**42 HAMPSTEAD LANE
LONDON, N6 4LL**

NMA APPLICATION II
DECEMBER 2023

SUMMARY OF CHANGES

CONSENTED VS NMA ii PROPOSALS

PROPOSED LOWER GROUND FLOOR

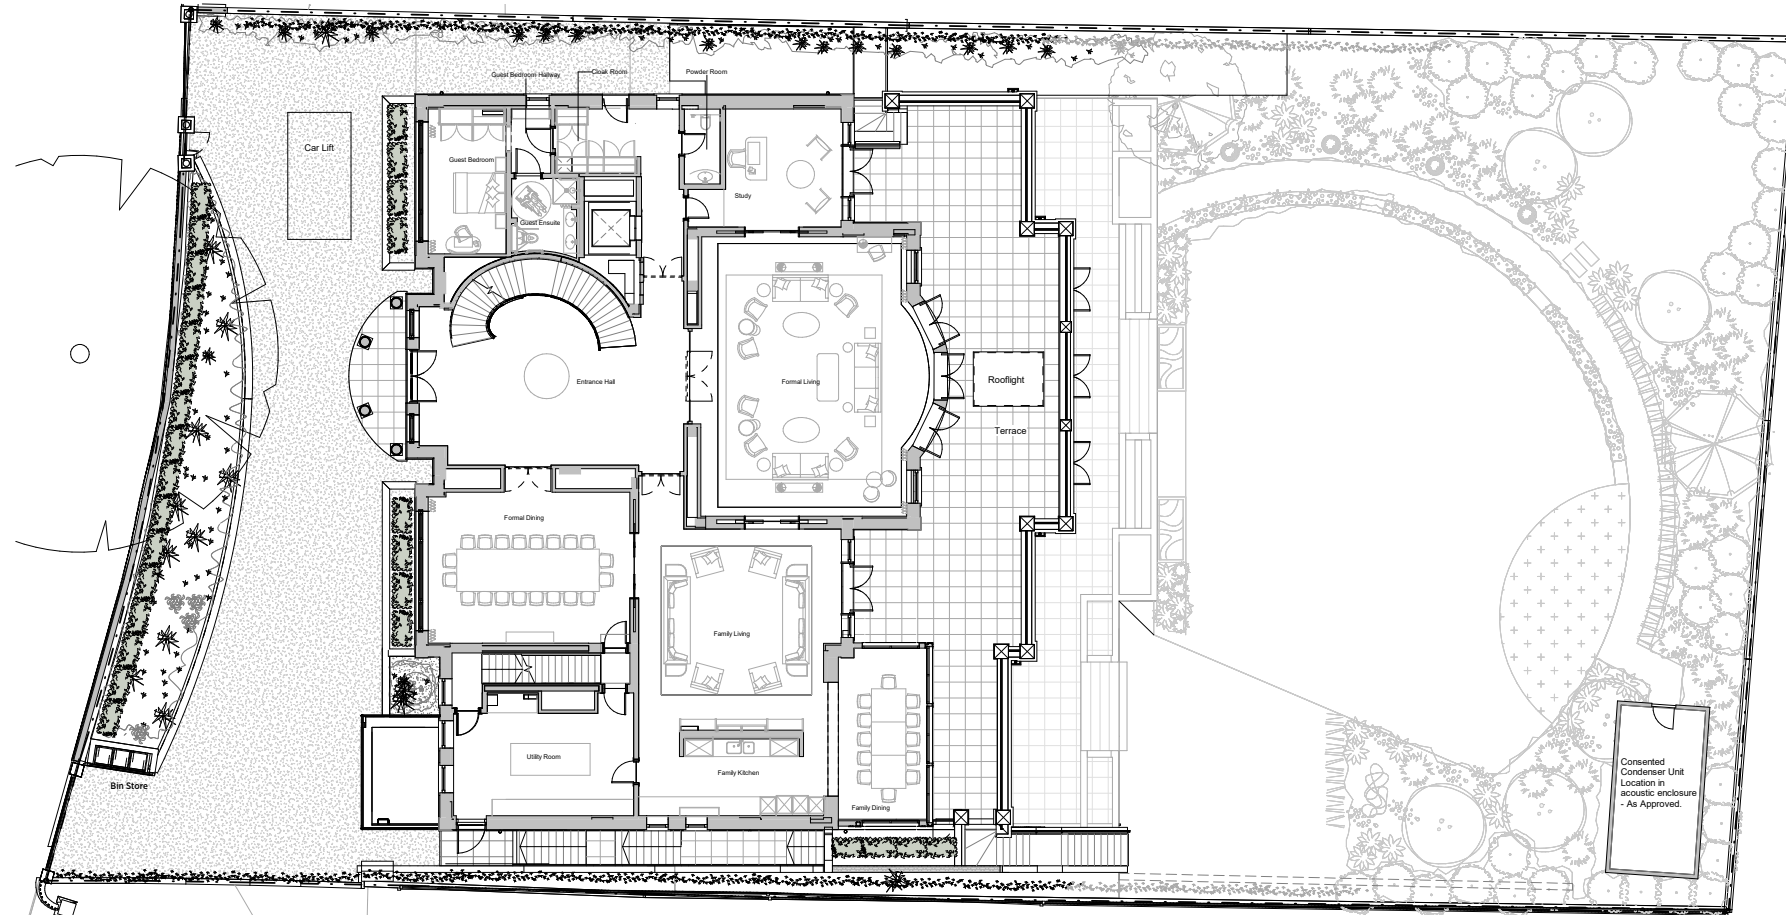
1. New door and new small gate
for dog's shed to rear stairs.
